Contract #: 04-0120F4  
 Cty: SF/ALA Rte: 80 PM: 13.2/13.9  
 File #: 69.25B

**QUALITY ASSURANCE -- NON-CONFORMANCE REPORT**

**Location:** Changxing Island, Shanghai, P.R. China **Report No:** NCR-000578  
**Prime Contractor:** American Bridge/Fluor Enterprises, a JV **Date:** 01-Jan-2010  
**Submitting Contractor:** Zhenhua Port Machinery Company, Ltd (ZPMC), Changxing Island **NCR #:** ZPMC-0551

**Reference Description:** The performed heat straightening in 6CW closed rib was deviated from the approved HSR procedure

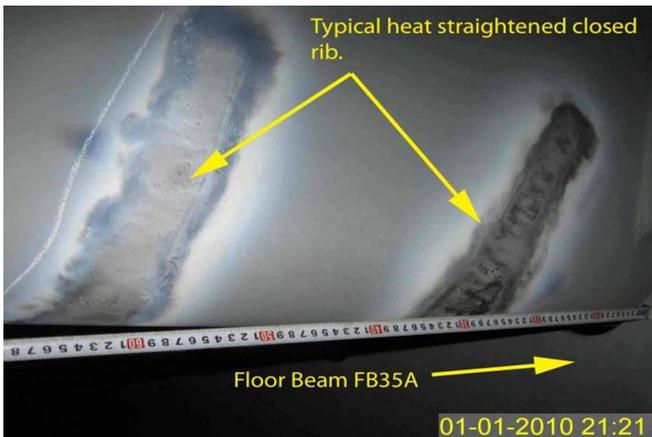
During the Quality Assurance in-process inspection of Closed Ribs being Heat Straightened at OBG segment 6CW, this Quality Assurance Inspector (QA) discovered the following issues:

- Deck Plates (DP) identified as: DP515A and DP275A are located inside segment 6CW.
- Heat Straightening (HS) was performed at two locations on each rib, one at approximately 160mm and the second at 620mm as measured from Floor Beam FB35A located at PP44 (as measured toward PP43).
- A total of seven (7) Closed Ribs were heat straightened. This is a deviation from the approved HSR document of heating the 3 closed ribs at the specified locations.
- Three (3) Closed Ribs were HS on DP515A and four (4) on DP275A.
- ZPMC QC or CWI were not present during the time of the HS process.
- Orthotropic Box Girder (OBG) segment 6CW is located in the Trial Assembly area.

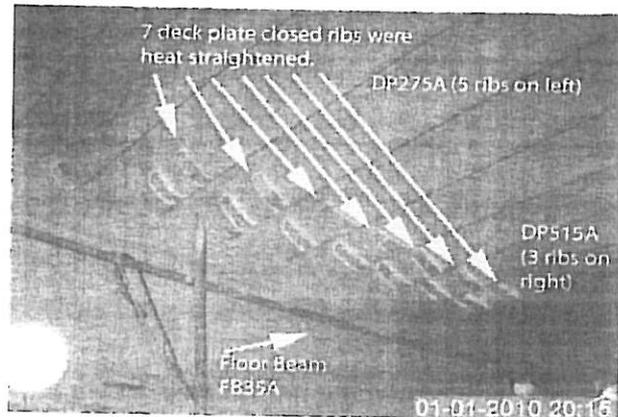
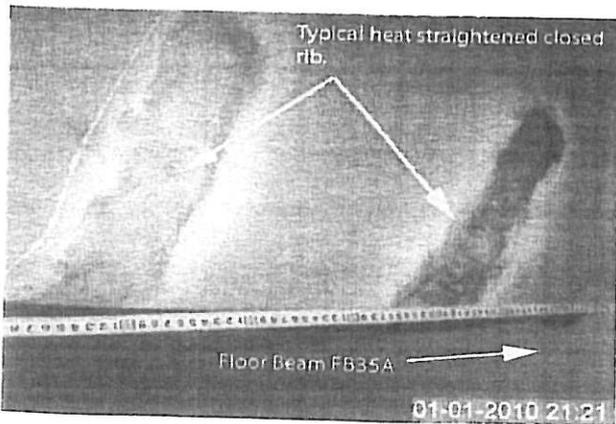
During the Quality Assurance in-process inspection of Closed Ribs being Heat Straightened at OBG segment 6CW, this Quality Assurance Inspector (QA) discovered the following issues:

- Deck Plates (DP) identified as: DP515A and DP275A are located inside segment 6CW.
- Heat Straightening (HS) was performed at two locations on each rib, one at approximately 160mm and the second at 620mm as measured from Floor Beam FB35A located at PP44 (as measured toward PP43).
- A total of seven (7) Closed Ribs were heat straightened. This is a deviation from the approved HSR document of heating the 3 closed ribs at the specified locations.
- Three (3) Closed Ribs were HS on DP515A and four (4) on DP275A.
- ZPMC QC or CWI were not present during the time of the HS process.
- Orthotropic Box Girder (OBG) segment 6CW is located in the Trial Assembly area.

报告号/Report No.:	HSR(B)-340
版本号/Revision No.:	1
日期/Date	2009.12.31

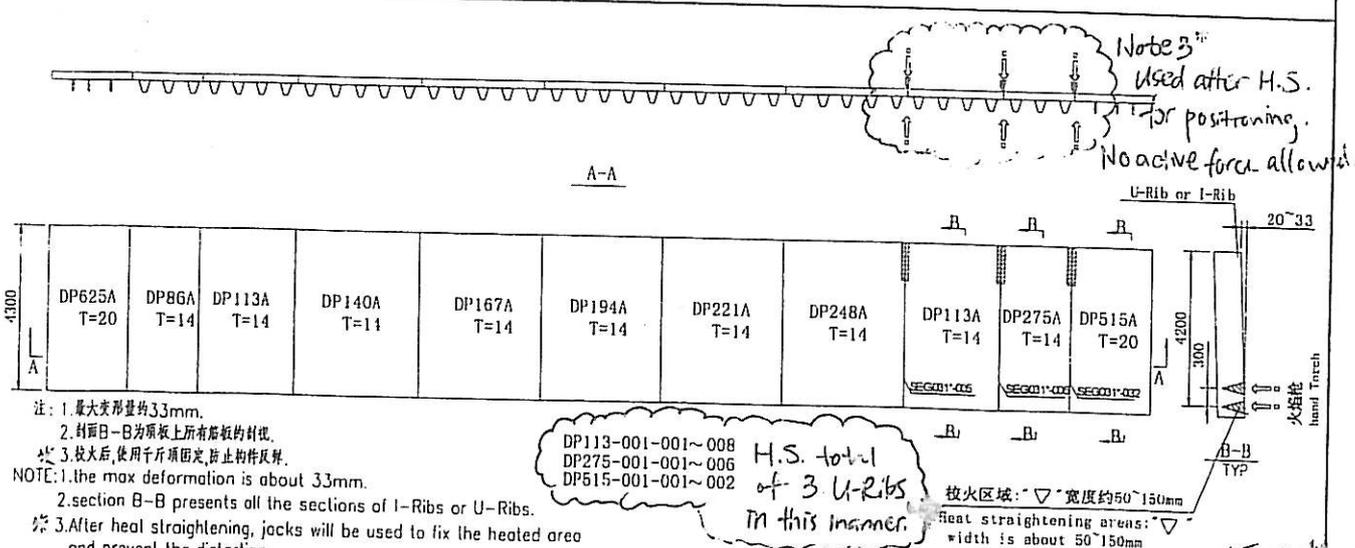
This NCR states the HSR specifies (3) closed ribs to be heat straightened while in fact 7 ribs were observed as showing heat marks. However, contrary to the NCR, the HSR is intended to mean 3 deck panels as shown in below the sketch of deck panels. A misunderstanding in nomenclature. In this case ZPMC was following the HSR. ABF QCM has discussed with ZPMC QA/QC that the CWI must be present during all heat straightening, if present, this misunderstanding could have been avoided as well as this NCR. ZPMC request closure of this NCR.

Submit a revised HSR that shows what was actually done.

DP113-001-001~008  
DP275-001-001~006  
DP515-001-001~002  
H.S. total of 3 U-Ribs in this manner.

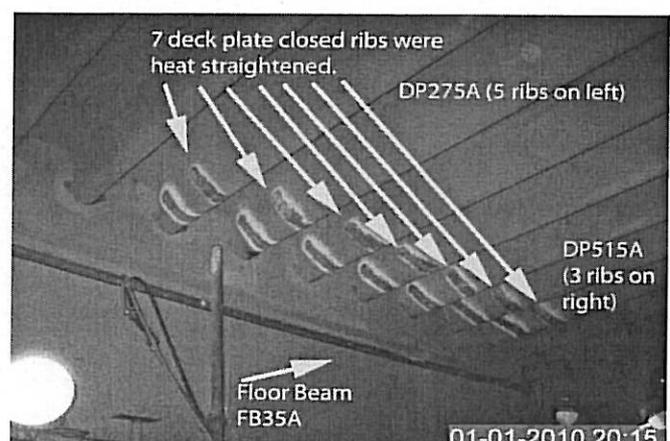
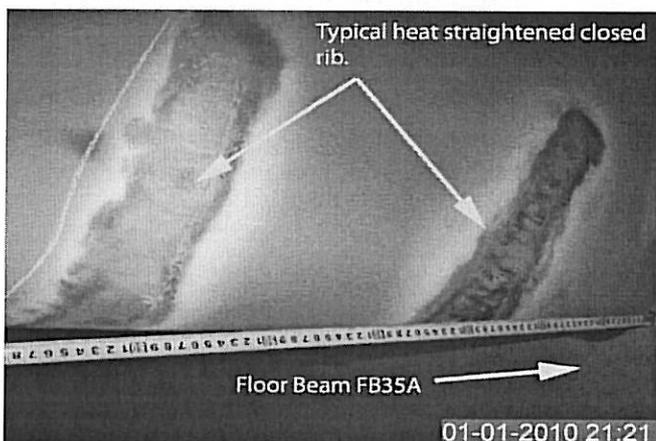
During the Quality Assurance in-process inspection of Closed Ribs being Heat Straightened at OBG segment 6CW, this Quality Assurance Inspector (QA) discovered the following issues:

- Deck Plates (DP) identified as: DP515A and DP275A are located inside segment 6CW.
- Heat Straightening (HS) was performed at two locations on each rib, one at approximately 160mm and the second at 620mm as measured from Floor Beam FB35A located at PP44 (as measured toward PP43).
- A total of seven (7) Closed Ribs were heat straightened. This is a deviation from the approved HSR document of heating the 3 closed ribs at the specified locations.
- Three (3) Closed Ribs were HS on DP515A and four (4) on DP275A.
- ZPMC QC or CWI were not present during the time of the HS process.
- Orthotropic Box Girder (OBG) segment 6CW is located in the Trial Assembly area.

报告号/Report No.:	HSR(B)-340
版本号/Revision No.:	2
日期/Date	2009.12.31

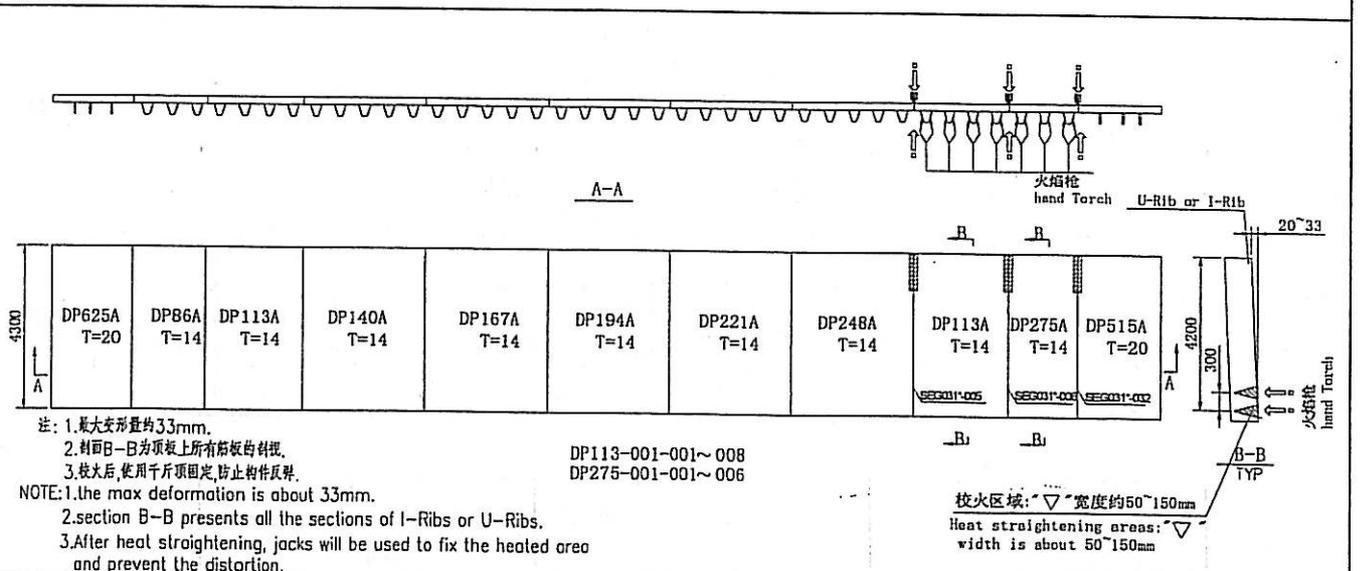
As per caltrans' comments in ABF-NPR-000460 R0. ZPMC provides the revised HSR for Engineer to review, requests closure of this NCR.

The documentation received is sufficient to close this NCR.

报告号/Report No.: HSR(B)-340  
 版本号/Revision No.: 1  
 日期Date: 2009.12.31

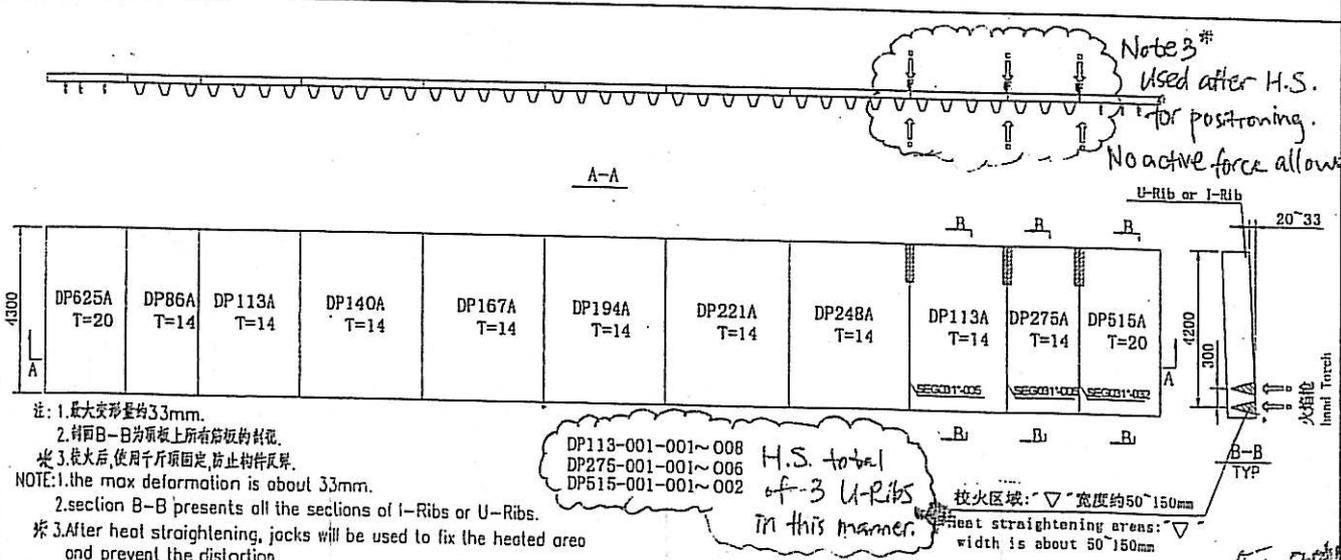
This NCR states the HSR specifies (3) closed ribs to be heat straightened while in fact 7 ribs were observed as showing heat marks. However, contrary to the NCR, the HSR is intended to mean 3 deck panels as shown in below the sketch of deck panels. A misunderstanding in nomenclature. In this case ZPMC was following the HSR. ABF QCM has discussed with ZPMC QA/QC that the CWI must be present during all heat straightening, if present, this misunderstanding could have been avoided as well as this NCR. ZPMC request closure of this NCR.

Submit a revised HSR that shows what was actually done.
